Access Compliance Report

Public Rights-of-Way

(Curb Ramps)

Intersection ID: 17967	Main Street: MONROE_RD	Cross Street: WALLACE_RD	Location: NE
ADA ID: 18F7684710A4	Ramp Type: PerpDiag	Initial Pass/Fail: Fail	Overall Compliance: No
		Severity Score: 22.5

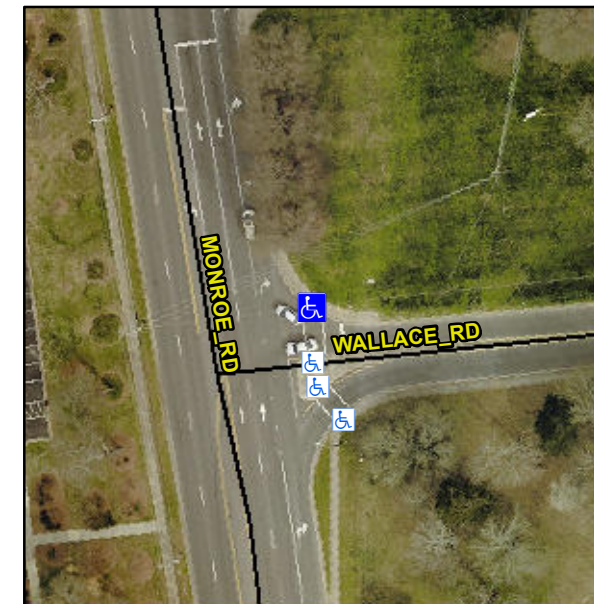
Not Found, R304.5.1, R304.2.2, R304.5.3

Compliance	Description	Data	Compliance	Description	Data
N/A	Ramp Length (in)	60.0	No	Ramp Slope (%)	8.8
No	Ramp Width (in)	44.0	No	Ramp XSlope (%)	2.6
N/A	Flare Type LT	N/A	N/A	Flare Type RT	N/A
N/A	Flare Slope LT (%)	N/A	N/A	Flare Slope RT (%)	N/A
N/A	Flare Traversable LT?	N/A	N/A	Flare Traversable RT?	N/A
N/A	Landing Length (in)	N/A	N/A	DWS Provided?	N/A
N/A	Landing Width (in)	N/A	N/A	DWS Contrast?	N/A
N/A	Landing Slope (%)	N/A	N/A	DWS Length (in)	N/A
N/A	Landing X Slope (%)	N/A	N/A	DWS Full Width?	N/A
N/A	Landing Curb? (Y/N)	N/A	N/A	DWS Offset (in)	N/A
N/A	Shared Landing?	N/A			
N/A	Gutter Ponding?	N/A	N/A	Gutter Slope (%)	N/A
N/A	Gutter Lip Ht (in)	N/A	N/A	Gutter X Slope (%)	N/A
N/A	Painted X Walk1?	No	N/A	Painted X Walk2?	Yes
	X Walk 1 Direction	To W		X Walk 2 Direction	To S
N/A	X Walk 1 Width (in)	N/A	N/A	X Walk 2 Width (in)	112.0
	X Walk 1 Slope (%)	1.9		X Walk 2 Slope (%)	3.8
	X Walk 1 X Slope (%)	2.1		X Walk 2 X Slope (%)	0.9

Remove & Replace Curb Ramp With Two New Directional Ramps or Equivalent.
